July 13, 2020  
Subject: Bridge Seal Replacement Projects  
State WINs: 022270.00 & 022324.00  
Location: **Auburn & Lewiston**  
**Amendment No. 2**

**REMOVE** page 46, SHEET NUMBER 3 OF 3 - JOINT SECTION VIEWS, and **REPLACE** with the attached, revised SHEET NUMBER 3 OF 3 - JOINT SECTION VIEWS.

**REMOVE** page 49, SHEET NUMBER 3 OF 4 - JOINT SECTION VIEWS, and **REPLACE** with the attached, revised SHEET NUMBER 3 OF 4 - JOINT SECTION VIEWS.

STATE OF MAINE DEPARTMENT OF TRANSPORTATION	VIETNAM MEMORIAL BRIDGE AUBURN ANDROSCOGGIN COUNTY	SHEET NUMBER 3
WIN 022270.00 BRIDGE NO. 6260	JOINT SECTION VIEWS OF 3

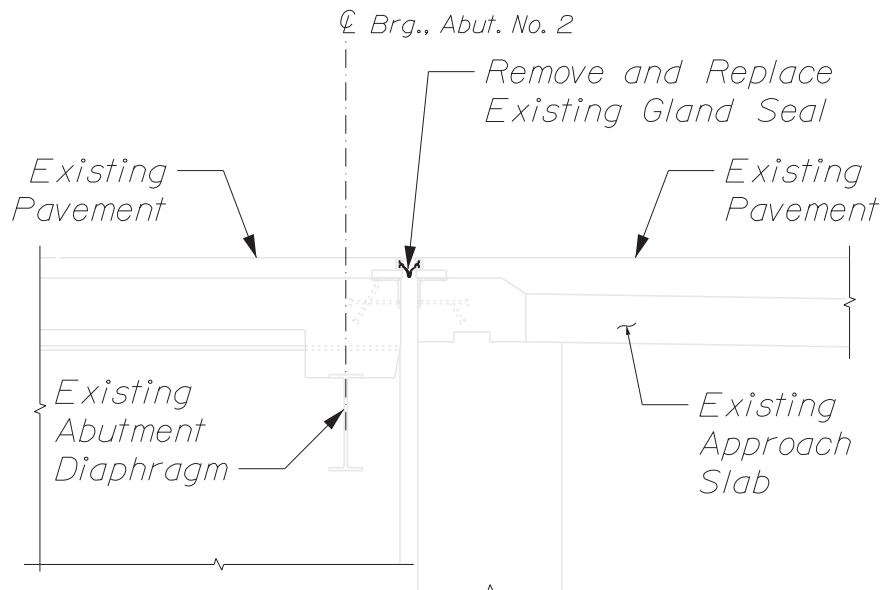
**Question:** In reference to both sets of drawings, drawing 3 of 3 and drawing 3 of 4 included in the contract bid book, on drawing 3 of 3 the note references Abutment 2 and 4 and the drawing is of Abutment No 1 and 2, is this information correct?

**Question:** On drawing 3 of 4 the note references Abutment 2 and 4 and the drawing is of Abutment No 3 and 4, is this information correct? Is the movement ratings correct on either drawing?

**Response:** Please see updated Joint Section Views drawings 3 of 3 and 3 of 4 for clarification.

1. Abutment 2 Gland seal shall have a minimum Movement Rating of 6.25". The Department will review the seals prior to fabrication of the expansion devices.
